Access Compliance Report

Public Rights-of-Way

Intersection ID: 4686	Main Street: EVANSHIRE_DR	Cross Street: TRINITY_RD	Location: SW
ADA ID: 362D200CD2CE	Ramp Type: BlendTrans2	Initial Pass/Fail: Fail	Overall Compliance: No
		Severity Score: 35

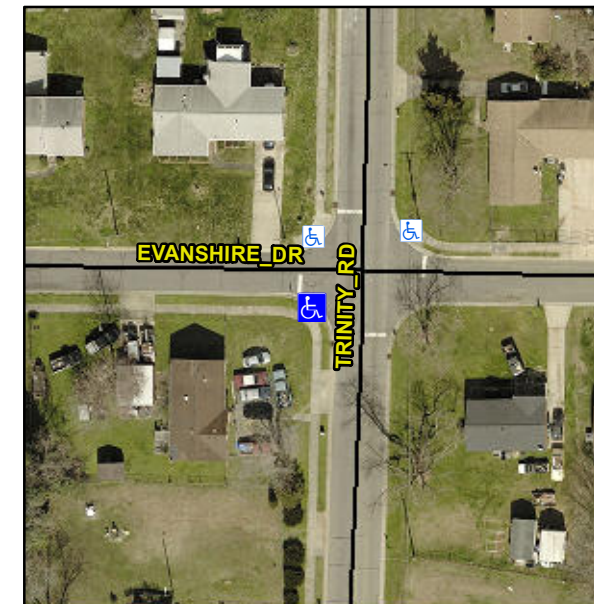
Not Found, R304.5.1

Compliance	Description	Data	Compliance	Description	Data
N/A	Ramp Length (in)	112.0	Yes	BlendTrans Slope (%)	4.2
No	Ramp Width (in)	29.0	Yes	BlendTrans XSlope (%)	1.4
N/A	Flare Type LT	N/A	N/A	Flare Type RT	N/A
N/A	Flare Slope LT (%)	N/A	N/A	Flare Slope RT (%)	N/A
N/A	Flare Traversable LT?	N/A	N/A	Flare Traversable RT?	N/A
N/A	Landing Length (in)	N/A	N/A	DWS Provided?	N/A
N/A	Landing Width (in)	N/A	N/A	DWS Contrast?	N/A
N/A	Landing Slope (%)	N/A	N/A	DWS Length (in)	N/A
N/A	Landing X Slope (%)	N/A	N/A	DWS Full Width?	N/A
N/A	Landing Curb? (Y/N)	N/A	N/A	DWS Offset (in)	N/A
N/A	Shared Landing?	N/A			
N/A	Gutter Ponding?	N/A	N/A	Gutter Slope (%)	N/A
N/A	Gutter Lip Ht (in)	N/A	N/A	Gutter X Slope (%)	N/A
N/A	Painted X Walk1?	No	N/A	Painted X Walk2?	N/A
	X Walk 1 Direction	To N		X Walk 2 Direction	N/A
	X Walk 1 Width (in)	N/A		X Walk 2 Width (in)	N/A
	X Walk 1 Slope (%)	3.0		X Walk 2 Slope (%)	N/A
	X Walk 1 X Slope (%)	1.4		X Walk 2 X Slope (%)	N/A

Remove & Replace Curb Ramp With Two New Directional Ramps or Equivalent.
